Access Compliance Report

Public Rights-of-Way

Intersection ID: 42492	Main Street: ALMA_BLOUNT_BV	Cross Street: JAMES_BLAKENEY_AV	Location: NE
ADA ID: 37D90951ECD4	Ramp Type: PerpDiag	Initial Pass/Fail: Fail	Overall Compliance: No
Severity Score: 30			
Codes/Mitigation Info/Possible Solution		Field Measurements/Component Compliance

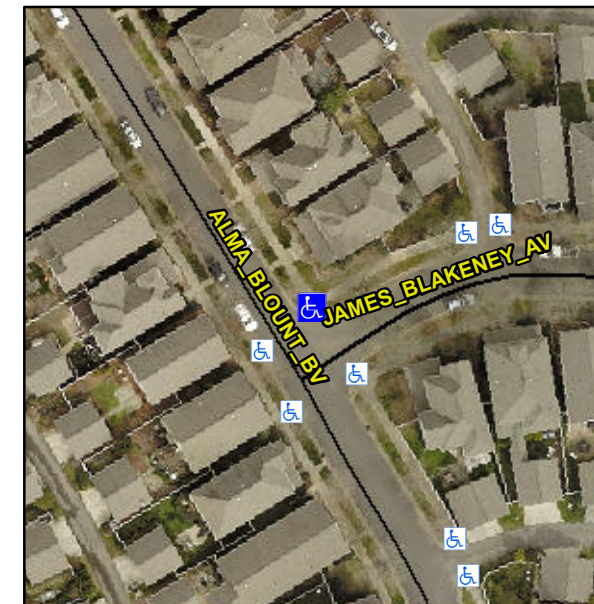
Remove & Replace Curb Ramp With Two New Directional Ramps or Equivalent.

R304.5.1, R304.2.2

Compliance	Description	Data	Compliance	Description	Data
N/A	Ramp Length (in)	77.0	No	Ramp Slope (%)	9.9
No	Ramp Width (in)	32.0	Yes	Ramp XSlope (%)	0.6
N/A	Flare Type LT	N/A	N/A	Flare Type RT	N/A
N/A	Flare Slope LT (%)	N/A	N/A	Flare Slope RT (%)	N/A
N/A	Flare Traversable LT?	N/A	N/A	Flare Traversable RT?	N/A
N/A	Landing Length (in)	N/A	N/A	DWS Provided?	N/A
N/A	Landing Width (in)	N/A	N/A	DWS Contrast?	N/A
N/A	Landing Slope (%)	N/A	N/A	DWS Length (in)	N/A
N/A	Landing X Slope (%)	N/A	N/A	DWS Full Width?	N/A
N/A	Landing Curb? (Y/N)	N/A	N/A	DWS Offset (in)	N/A
N/A	Shared Landing?	N/A			
N/A	Gutter Ponding?	N/A	N/A	Gutter Slope (%)	N/A
N/A	Gutter Lip Ht (in)	N/A	N/A	Gutter X Slope (%)	N/A
N/A	Painted X Walk1?	No	N/A	Painted X Walk2?	No
	X Walk 1 Direction	To SW		X Walk 2 Direction	To SE
N/A	X Walk 1 Width (in)	N/A	N/A	X Walk 2 Width (in)	N/A
	X Walk 1 Slope (%)	0.5		X Walk 2 Slope (%)	0.0
	X Walk 1 X Slope (%)	0.1		X Walk 2 X Slope (%)	1.0
